Product Change Notice (PCN)

Subject: Notice of Change in 14 x 14 mm LQFP Tape & Reel Packaging Components for RX100/200/600 Products

change Tape & Reel packaging for RX LQFP PRODUCTS DIFFERENCE DOCUMENT

IMO-AB-22-0089

2. Difference of specification's detail (1)

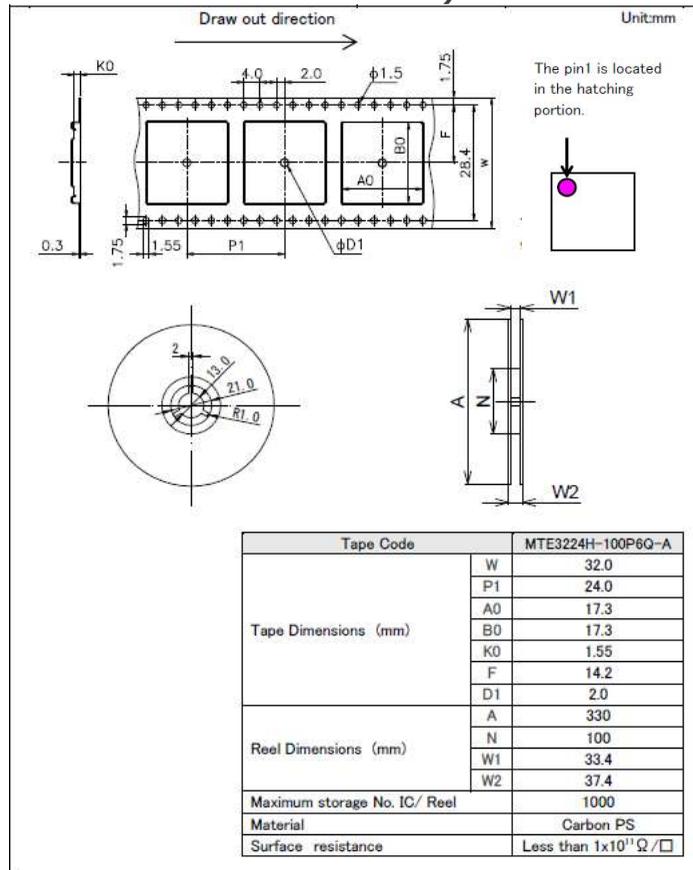
Comparison of tape & reel material details: 14x14mm LQFP Tape & Reel packaging

| Packing material | Item | Before | After |
|------------------|---------------------------------|----------------------|----------------------|
| Emboss tape | Taping code | MTE3224H-100P6Q-A | E2424Q14RA |
| | Sprocket hole | Both side | One side |
| | Tape width | 32mm | 24mm |
| | Cavity size | 17.3x17.3 | 16.5x16.5 |
| | Cavity depth | 1.55mm | 1.4mm |
| | Reel width | For 32-mm width tape | For 24-mm width tape |

2. Difference of specification's detail (2)

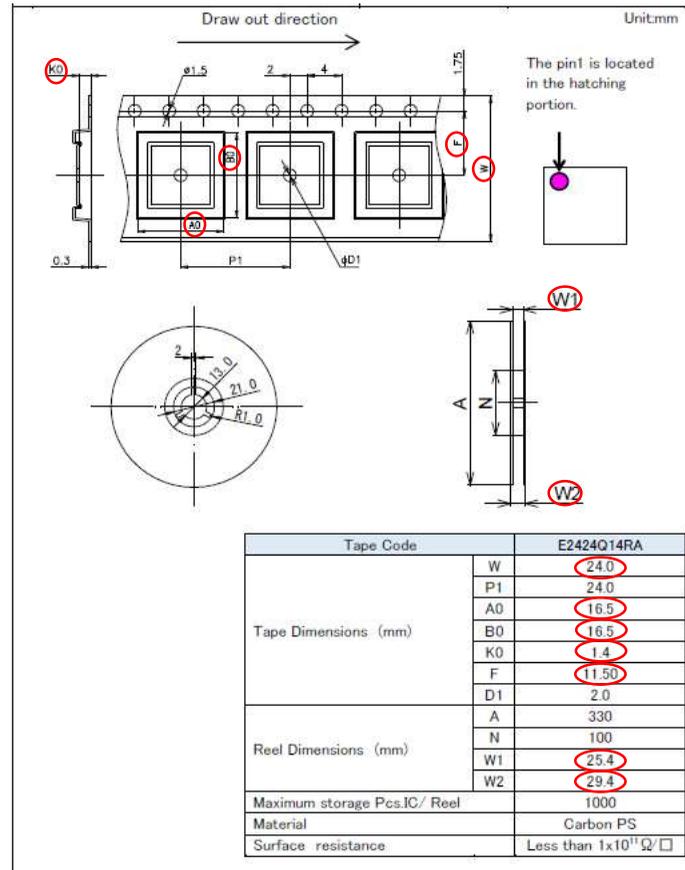
Comparison of tape & reel dimension: 14mm x14mm Tape & Reel LQFP Tape & Reel packaging

Before (W:32mm)

After (W:24mm)
